Access Compliance Report

Public Rights-of-Way

(Curb Ramps)

Intersection ID: 2901	Main Street: CRAGLAND_CT	Cross Street: HARBURN_FOREST_DR	Location: NW
ADA ID: C2EAEBD9E102	Ramp Type: PerpDiag	Initial Pass/Fail: Fail	Overall Compliance: No
Severity Score: 25			
Codes/Mitigation Info/Possible Solution		Field Measurements/Component Compliance

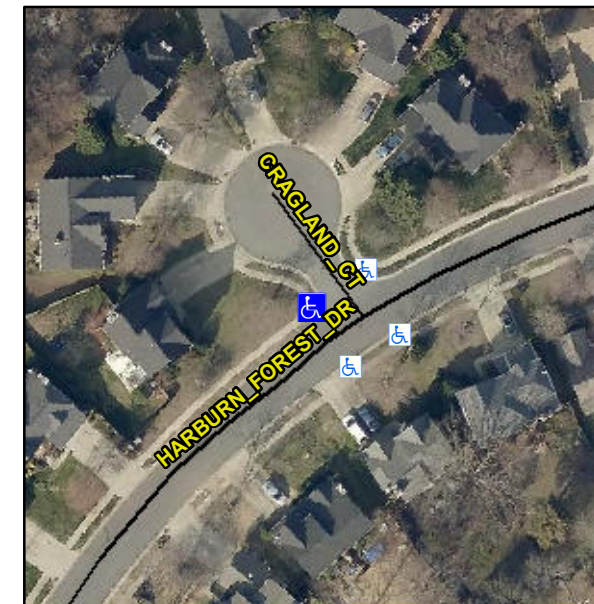
Not Found, R304.2.2

Compliance	Description	Data	Compliance	Description	Data
N/A	Ramp Length (in)	47.0	No	Ramp Slope (%)	12.5
Yes	Ramp Width (in)	48.0	Yes	Ramp XSlope (%)	1.1
N/A	Flare Type LT	N/A	N/A	Flare Type RT	N/A
N/A	Flare Slope LT (%)	N/A	N/A	Flare Slope RT (%)	N/A
N/A	Flare Traversable LT?	N/A	N/A	Flare Traversable RT?	N/A
N/A	Landing Length (in)	N/A	N/A	DWS Provided?	N/A
N/A	Landing Width (in)	N/A	N/A	DWS Contrast?	N/A
N/A	Landing Slope (%)	N/A	N/A	DWS Length (in)	N/A
N/A	Landing X Slope (%)	N/A	N/A	DWS Full Width?	N/A
N/A	Landing Curb? (Y/N)	N/A	N/A	DWS Offset (in)	N/A
N/A	Shared Landing?	N/A			
N/A	Gutter Ponding?	N/A	N/A	Gutter Slope (%)	N/A
N/A	Gutter Lip Ht (in)	N/A	N/A	Gutter X Slope (%)	N/A
N/A	Painted X Walk1?	No	N/A	Painted X Walk2?	No
	X Walk 1 Direction	To S		X Walk 2 Direction	To E
N/A	X Walk 1 Width (in)	N/A	N/A	X Walk 2 Width (in)	N/A
	X Walk 1 Slope (%)	3.5		X Walk 2 Slope (%)	2.1
	X Walk 1 X Slope (%)	1.8		X Walk 2 X Slope (%)	1.4

Remove & Replace Curb Ramp With Two New Directional Ramps or Equivalent.
